Type <b>Coffee Vending Machine</b>	Model <b>95</b>	N° T.I. <b>02 - 2023</b>
Serial Number <b>22120630</b>	Subject <b>LEAD FREE MACHINE</b>	ISSUED FOR (X) Action Information <b>X</b>

A *lead-free* version (code **975821**) was introduced, derived from the existing *95 machine* (code 975803).

**Lead - free Assembly Boiler**

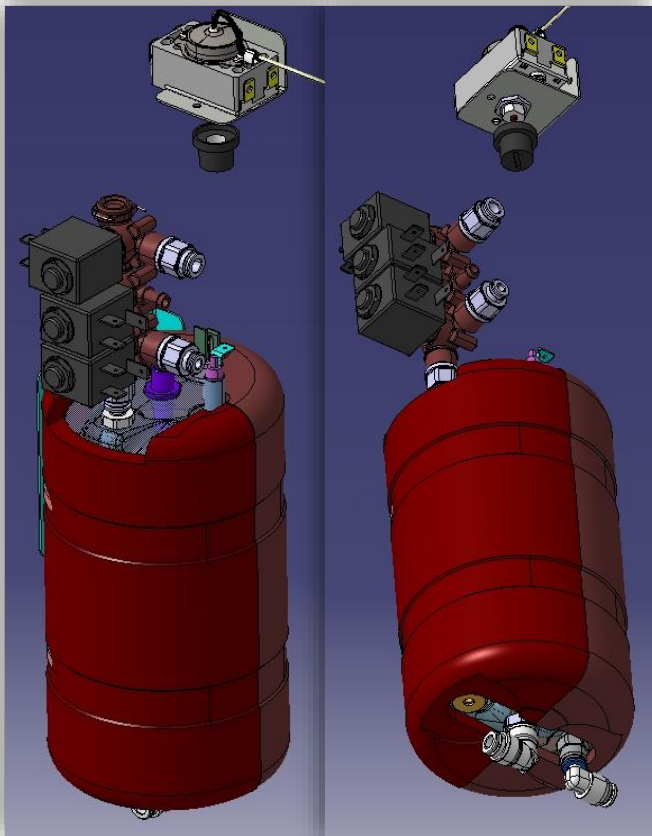
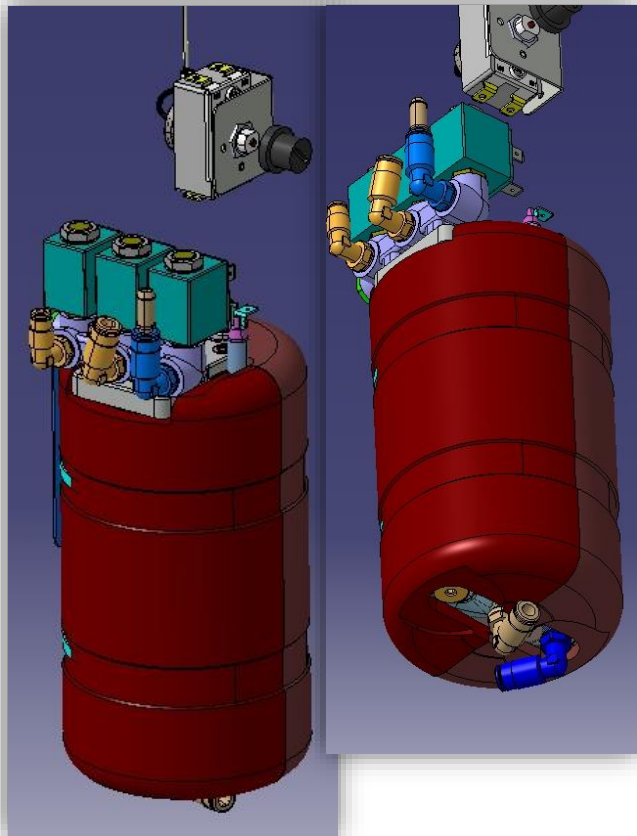
**Not lead - free Assembly Boiler**

Spare code: **265326**

Spare code: **261906**

**Lead-free (Plastic) solenoid valves**

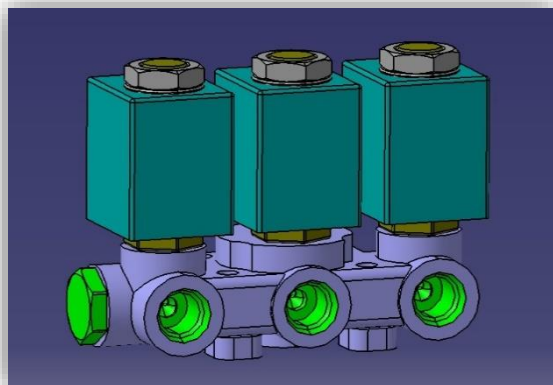
**Not lead-free solenoid valves**

Spare code: **265325**

Spare code: **259911**

**Fittings on Solenoid valves**

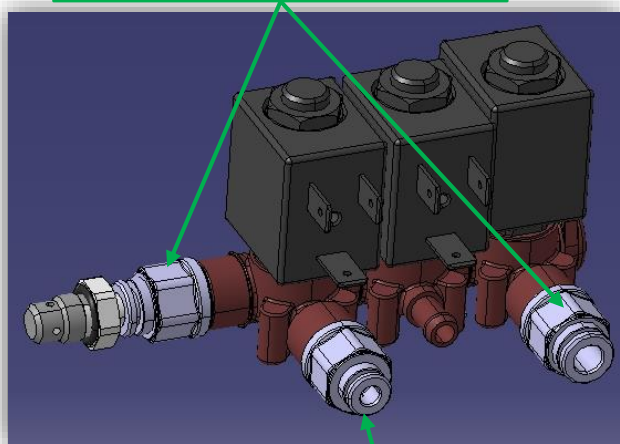
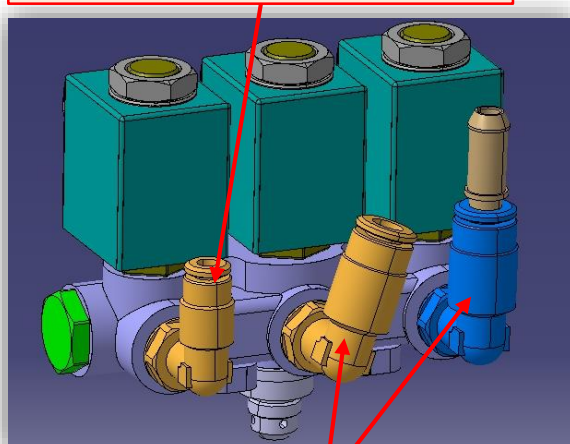
**Lead Free**

**G1/8 Ø6 Straight quick Fitting**  
Spare code: **263425**

**Teflon Ø4-G1/8 PPS connection**  
Spare code: **264387**

**Not Lead Free**

**L Rotating with OR 4-1/8 unleaded**  
Spare code: **256273**

**L Rotating with OR 6-1/8 unleaded**  
Spare code: **256280**

**Plastic Non return valve + By\_pass**  
Spare code: **262764**

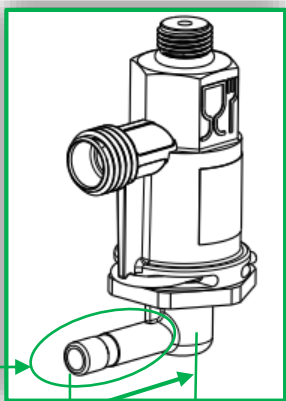
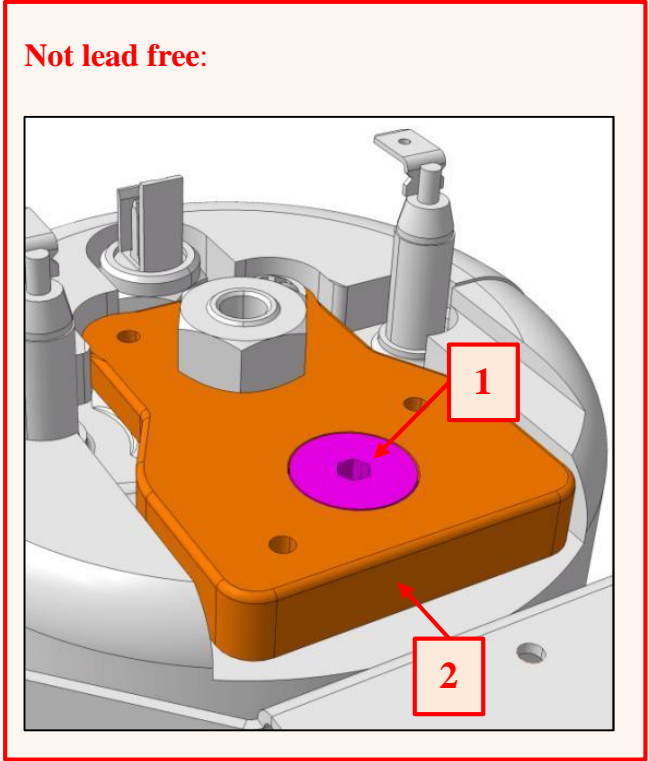
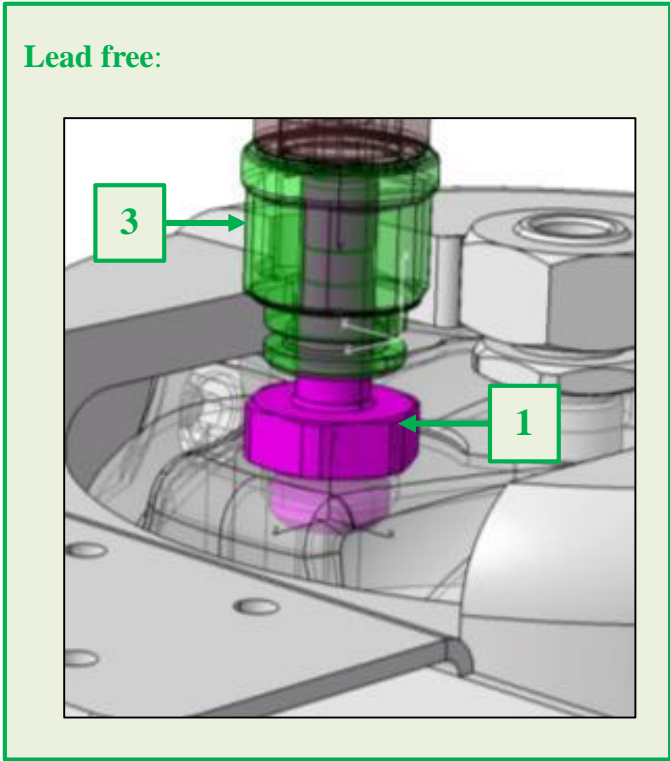
**Modified Outlet profile**

**D<sub>new</sub>**

**Still used on: 975803**  
Spare code: **257729**

**D<sub>standard</sub>**

**IN / OUT BOILER**

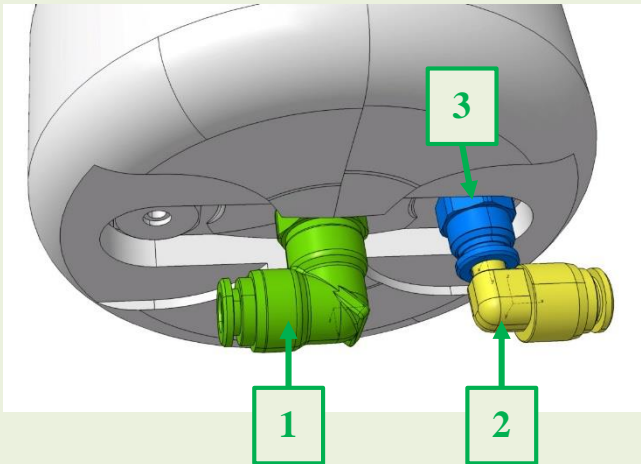
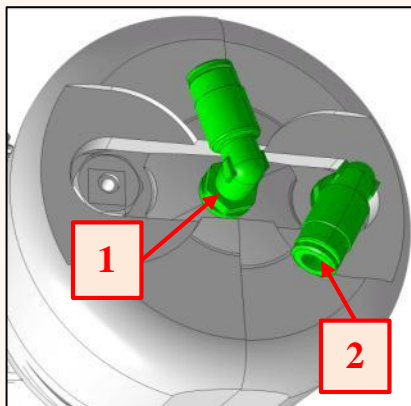
Description	Spare Code
1	Tube swiveling fitting for teflon-6 (boiler inlet)	264385
2	Swiveling fitting for teflon-6 (boiler drain)	263427
3	Straight fitting d.6 inox	264386

Description	Spare Code
1	Tube swiveling fitting for teflon-6 (boiler inlet)	258904
2	Swiveling fitting for teflon-6 (boiler drain)	256280

**EV Z4000 –ES/FB**

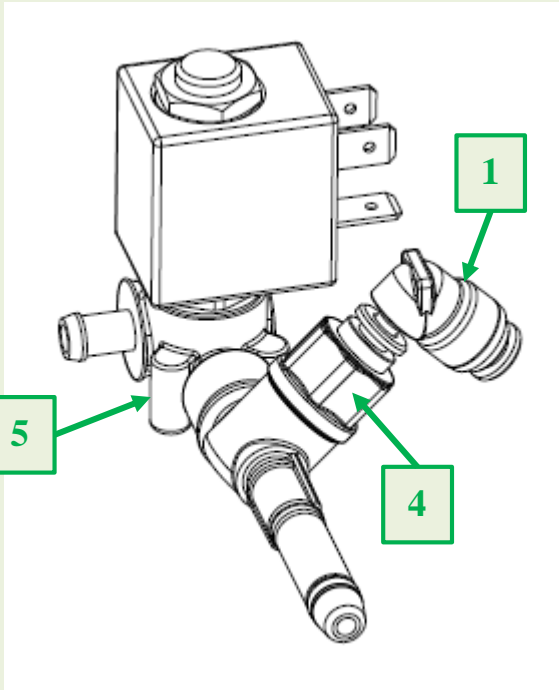
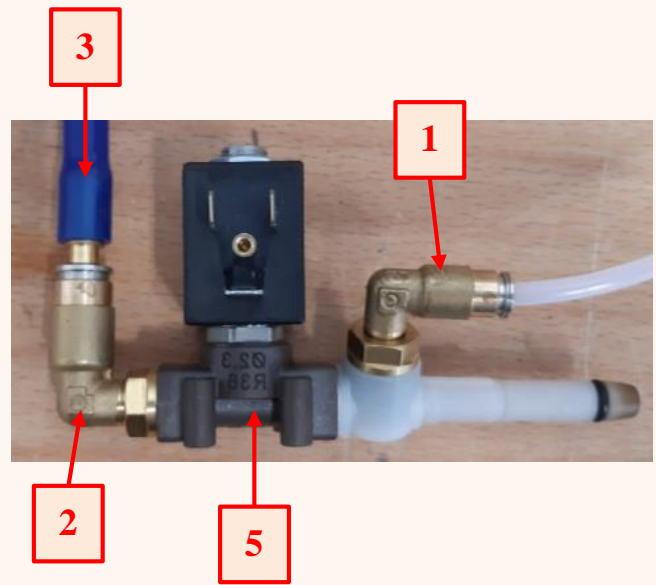
Description	Spare Code
1 L-swiveling for teflon-4	<b>264388</b>
4 Straight fitting for teflon-4	<b>264387</b>
5 EV	<b>264390</b>

Description	Spare Code
1 L-swiveling for teflon-4	<b>256273</b>
2 Swiveling fitting for teflon-6	<b>256280</b>
3 Teflon / silicone adapter	<b>258914</b>
5 EV	<b>258764</b>
